HISTORIC AND DESIGN REVIEW COMMISSION

March 02, 2022

HDRC CASE NO: 2022-110
ADDRESS: 1803 BROADWAY
LEGAL DESCRIPTION: NCB 969 (OXBOW OFFICE CONDOMINIUM), BLOCK 1 LOT 20
****MASTER FILE-COMMON ELEMENT****
ZONING: IDZ, RIO-2
CITY COUNCIL DIST.: 1
APPLICANT: Chakeyia Smith/Apex Sign Group, LLC
OWNER: LIFSHUTZ COMPANIES LP
TYPE OF WORK: Signage
APPLICATION RECEIVED: February 09, 2022
60-DAY REVIEW: Not applicable due to City Council Emergency Orders
CASE MANAGER: Edward Hall

SIGN A1	Maverick Restaurant Group
Type:	Flag Mount Sign w/ Aluminum FCO's
Illumination:	Externally Illuminated LED
Square Footage:	11.83

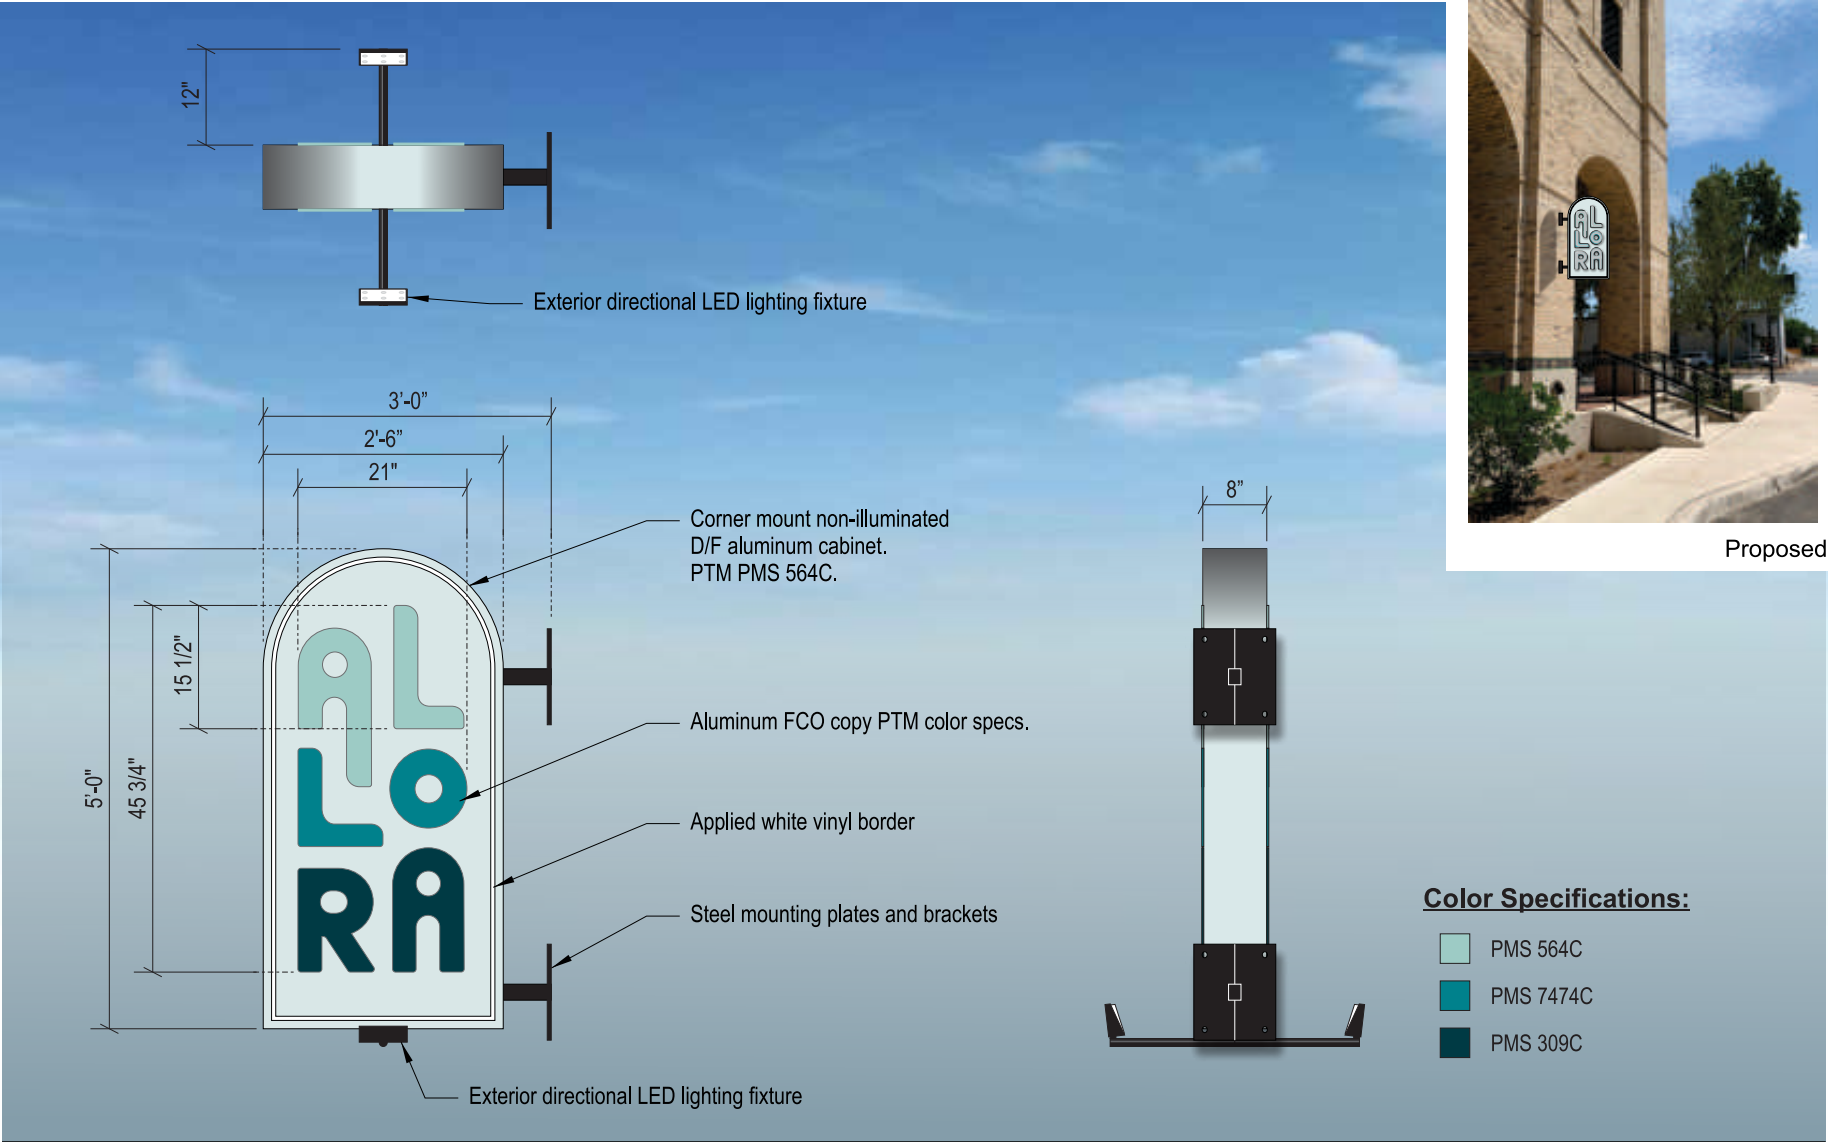
1. Modify and relocate a previously approved corner blade sign to feature an overall size of 3' – 0" in width and 5' – 0" in height rather than 3' – 0" in width and 6' – 0" in height. The proposed signage will remain externally illuminated and constructed of aluminum; however, the sign will be located solely on Pearl Parkway. The proposed signage will feature approximately thirty (30) square feet in size, including both sides. This sign is identified as sign A1 in the application documents.

- d. BLADE SIGN (A1)– The applicant has proposed to modify and relocate a previously approved corner blade sign to feature an overall size of 3' – 0" in width and 5' – 0" in height rather than 3' – 0" in width and 6' – 0" in height. The proposed signage will remain externally illuminated and constructed of aluminum; however, the sign will be located solely on Pearl Parkway. The proposed signage will feature approximately thirty (30) square feet in size, including both sides. This sign is identified as sign A1 in the application documents. Generally, staff finds the request to be appropriate and consistent with the UDC. Staff finds the overall size of the proposed blade signs to be proportionate to the building's massing.

Staff recommends approval of items #1 through #6 as submitted.

SIGN A2	Maverick Restaurant Group
Type:	Flag Mount Sign w/ Aluminum FCO's
Illumination:	Externally Illuminated LED
Square Footage:	11.83

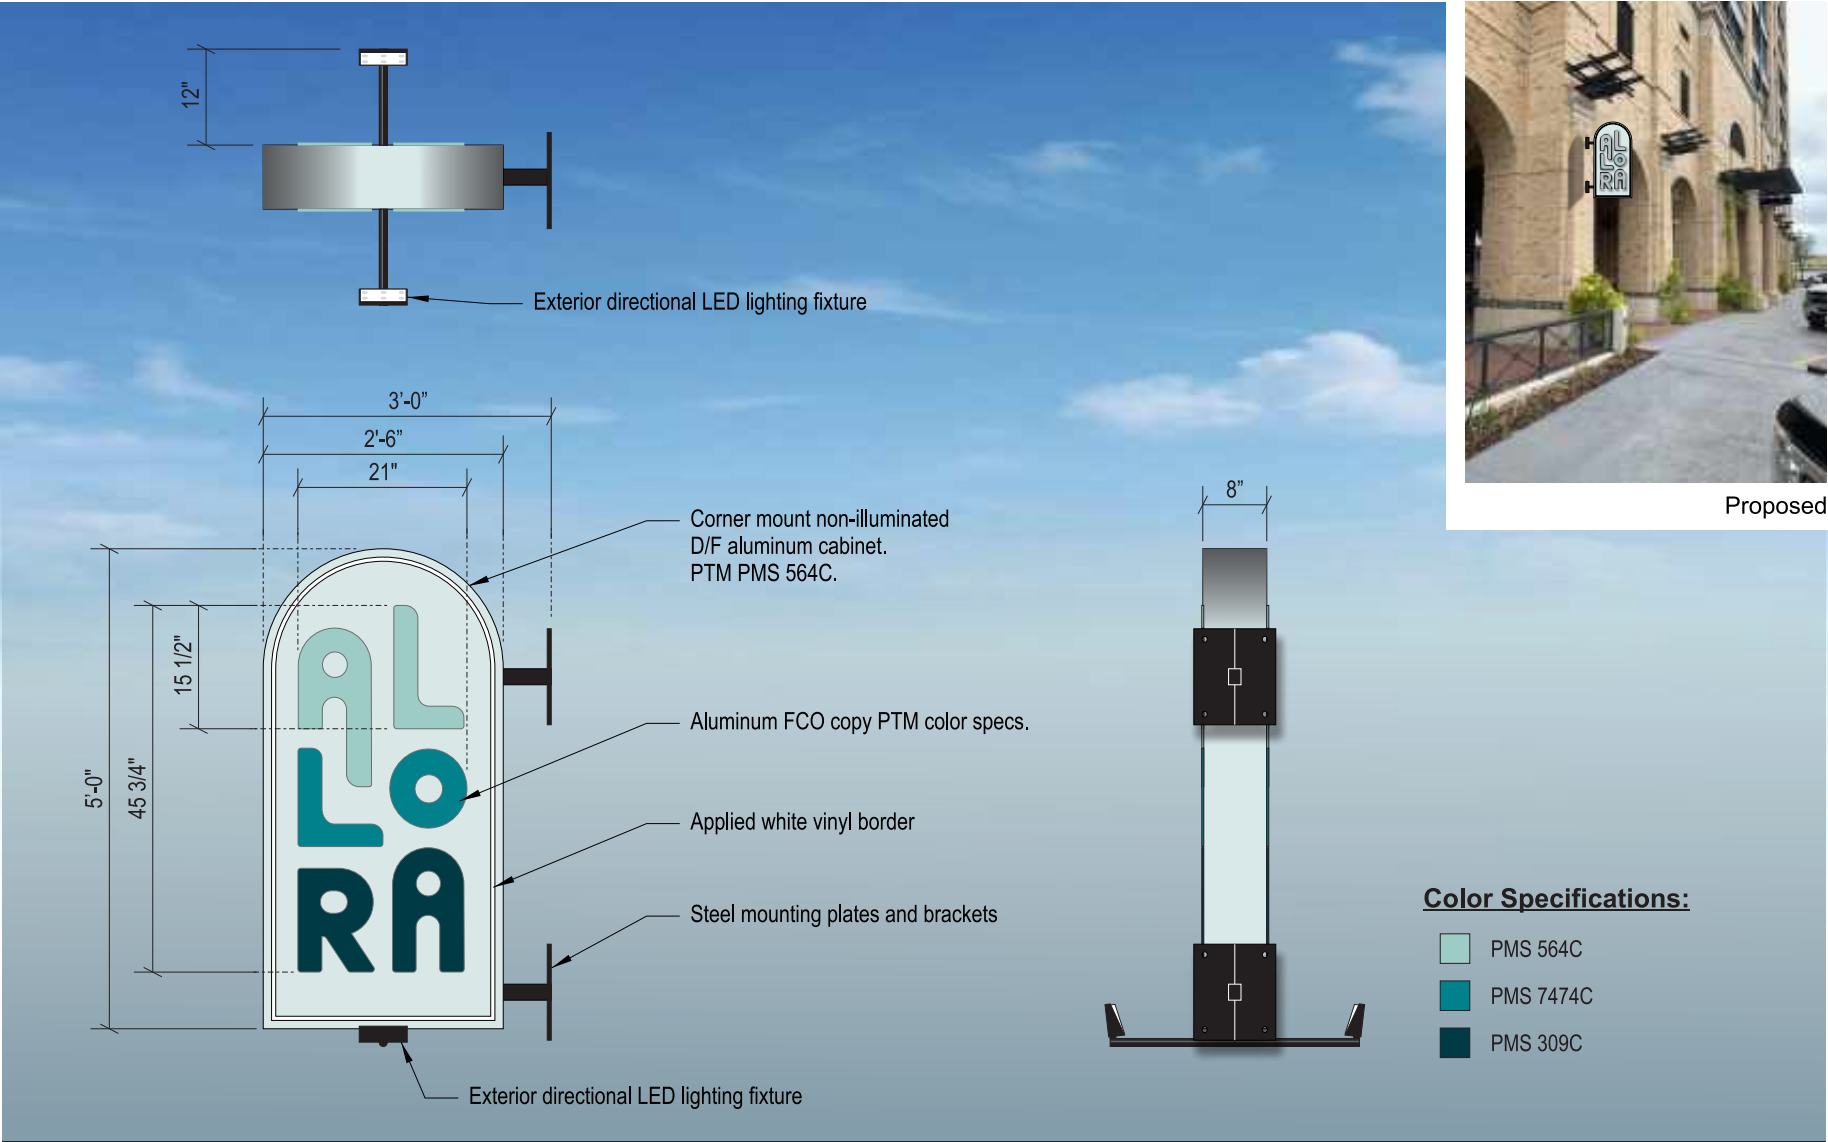
2. Install a blade sign to feature to feature an overall size of 3' – 0" in width and 5' – 0" in height for an overall size of approximately thirty (30) square feet, including both sides. The proposed signage will feature aluminum faces and external illumination. This sign is identified as sign A2 in the application documents.

- e. BLADE SIGN (A2) – The applicant has proposed to install a blade sign to feature an overall size of 3' – 0" in width and 5' – 0" in height for an overall size of approximately thirty (30) square feet, including both sides. The proposed signage will feature aluminum faces and external illumination. This sign is identified as sign A2 in the application documents. Generally, staff finds the request to be appropriate and consistent with the UDC. Staff finds the overall size of the proposed blade signs to be proportionate to the building's massing.

SIGN D	Maverick Restaurant Group
Type:	Monument
Illumination:	Internally Illuminated w/ LEDs
Square Footage:	28.00

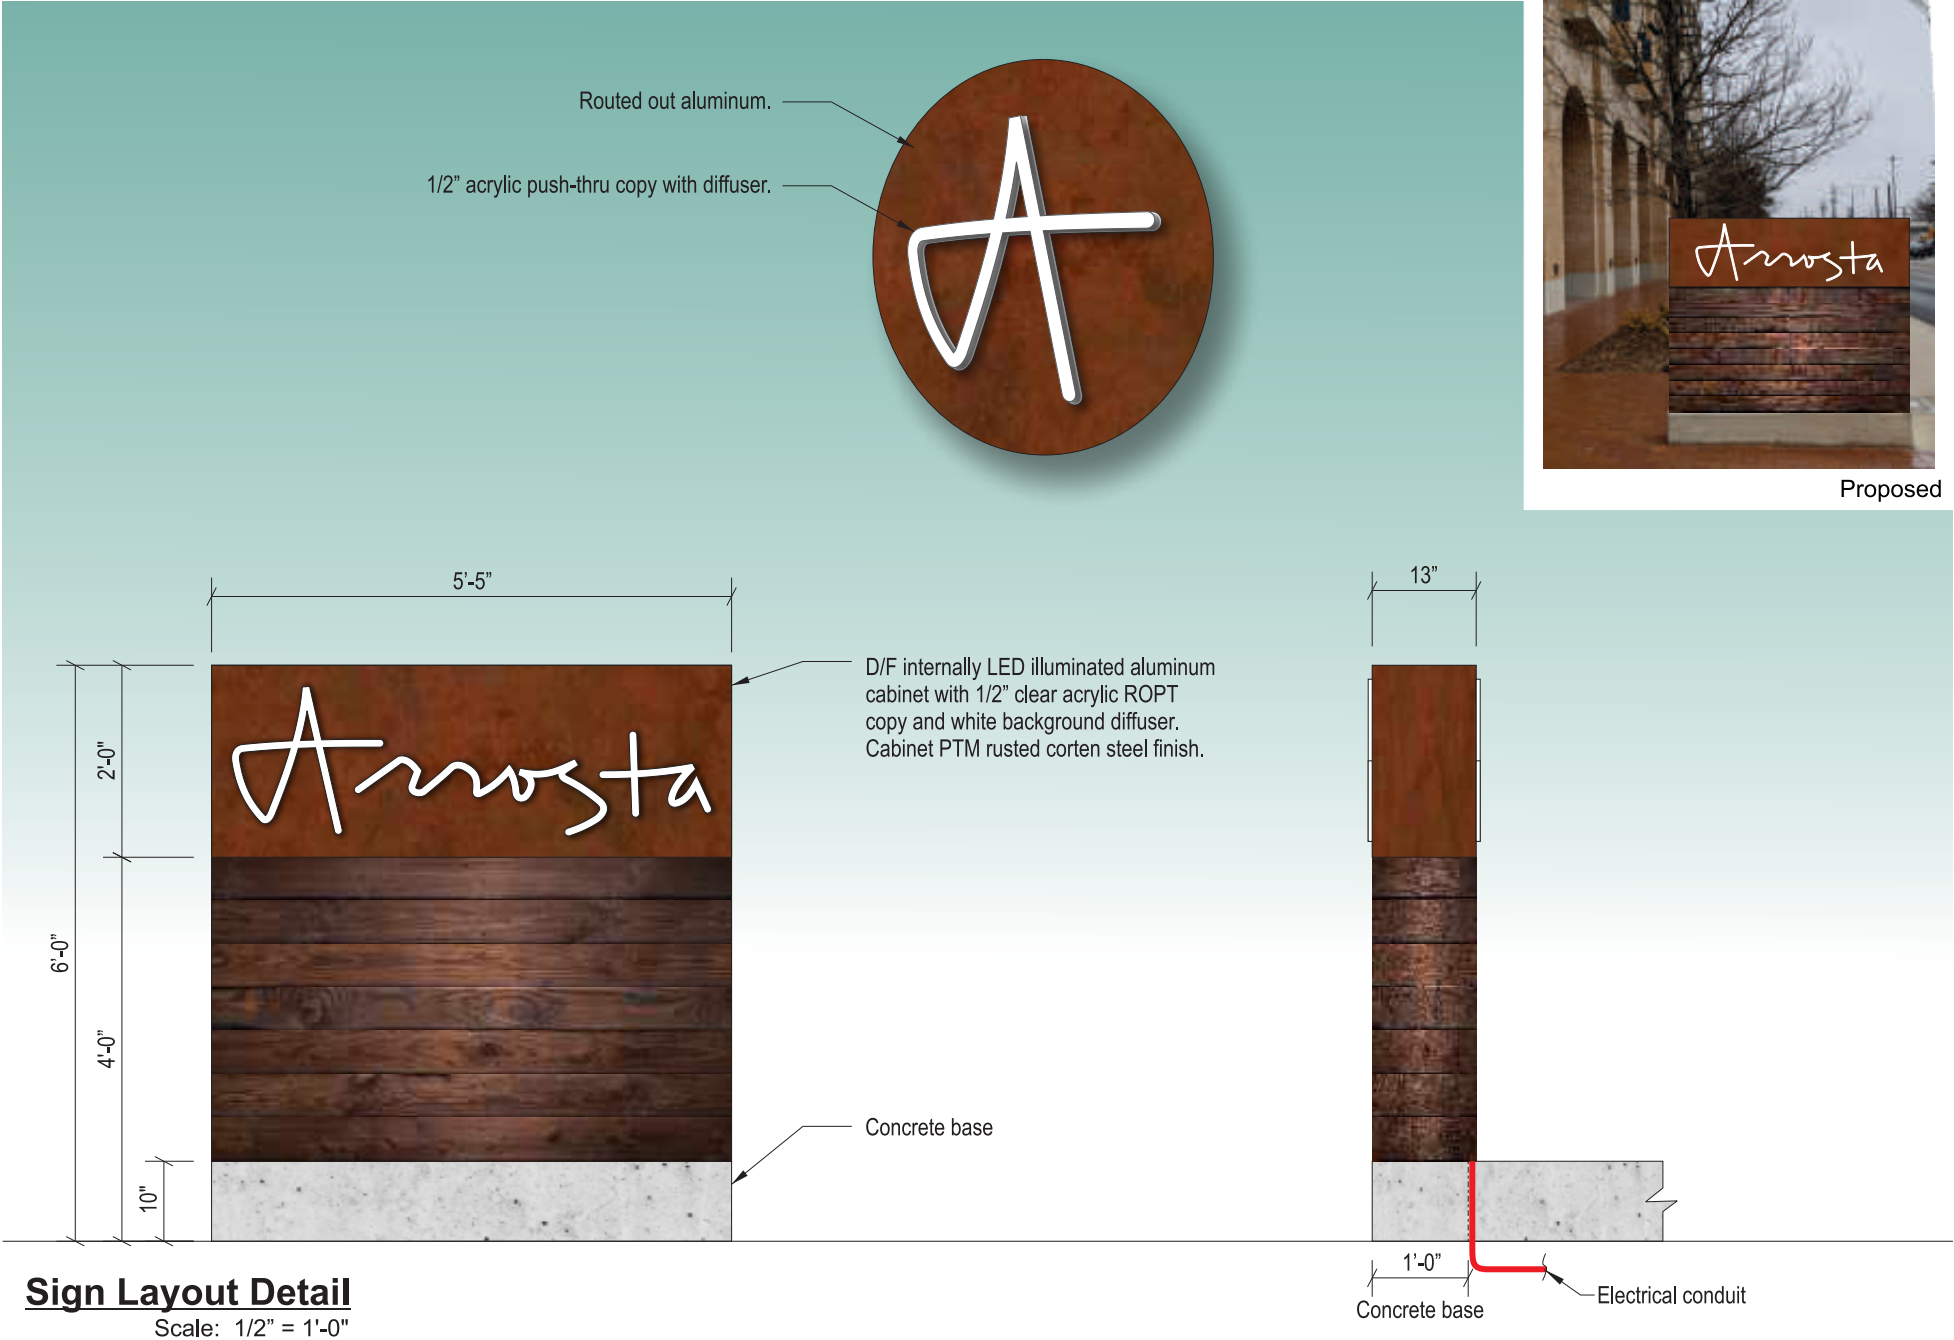
3. Install a monument sign along Broadway to feature an overall height of 6' – 6" and an overall width of 5' – 5". The proposed sign will feature a concrete base and wood and metal faces. The sign will feature internal illumination with routed metal faces. The proposed sign will feature an overall size of approximately 71.5 square feet, including both sides. This sign is identified as sign D in the application documents.

- f. MONUMENT SIGN (A3) – The applicant has proposed to install a monument sign along Broadway to feature an overall height of 6' – 0" and an overall width of 5' – 5". The proposed sign will feature a concrete base and wood and metal faces. The sign will feature internal illumination with routed metal faces. The proposed sign will feature an overall size of approximately 71.5 square feet, including both sides. This sign is identified as sign D in the application documents. Staff finds the proposed signage to be appropriate and consistent with the UDC.

SIGN E	Maverick Restaurant Group
Type:	Wall Sign - Deliveries
Illumination:	Non-Illuminated
Square Footage:	TBD

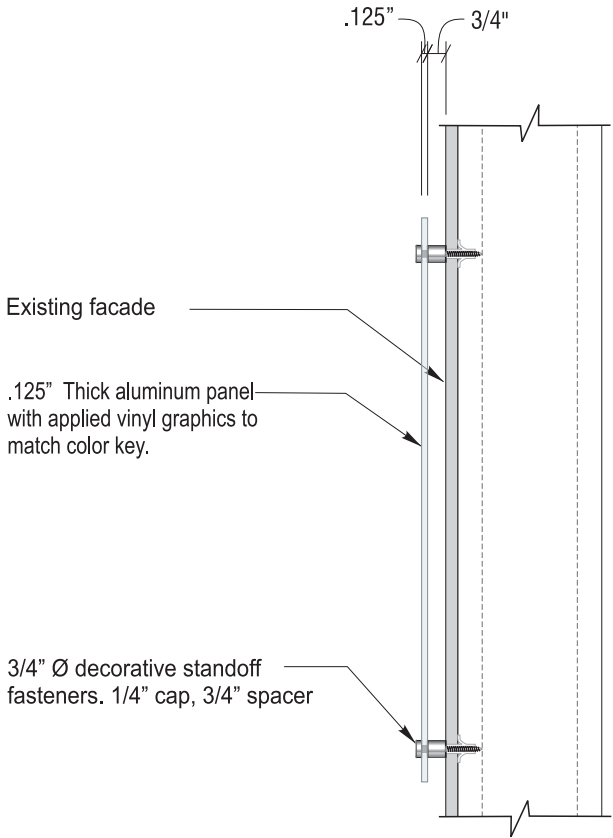
4. Install incidental signage to note deliveries. The proposed signage will feature eighteen (18) inches in height and eighteen (18) inches in width for a total size of approximately 2.25 square feet. This sign is identified as sign E in the application documents.

- g. INCIDENTAL SIGNAGE (A4) – The applicant has proposed to install incidental signage to note deliveries. The proposed signage will feature eighteen (18) inches in height and eighteen (18) inches in width for a total size of approximately 2.25 square feet. This sign is identified as sign E in the application documents. Staff finds the proposed signage to be appropriate.

SIGN F	Maverick Restaurant Group
Type:	Window Vinyl
Illumination:	Non-Illuminated
Square Footage:	1.63 + 1.37 = 3.00

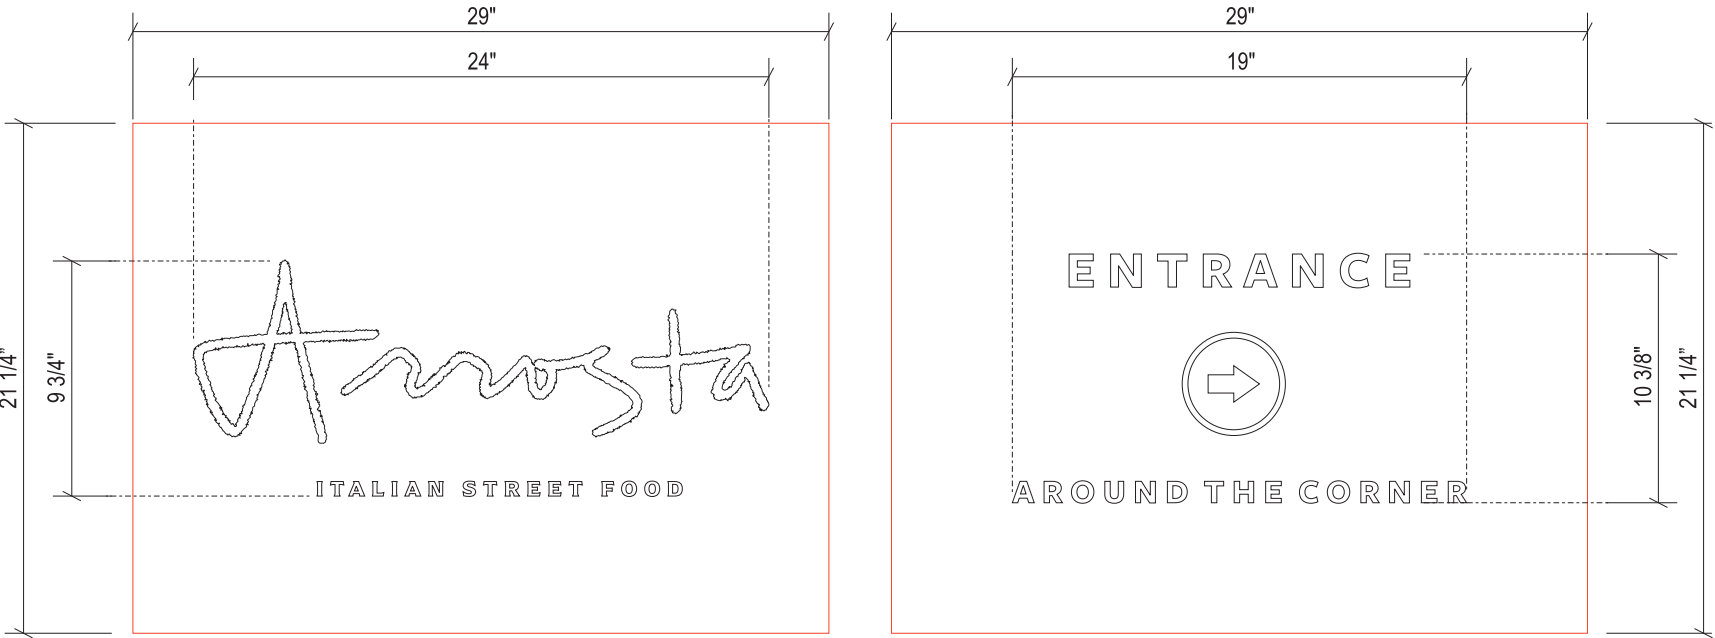
5. Install two vinyl graphics on entrance doors within the open-air arcade to feature approximately 3 square feet in size. These signs are identified as signs F in the application documents.

- h. VINYL GRAPHICS (A5) – The applicant has proposed to install two vinyl graphics on entrance doors within the open-air arcade to feature approximately 3 square feet in size. These signs are identified as signs F in the application documents. Staff finds the proposed signage to be appropriate and consistent with the UDC.
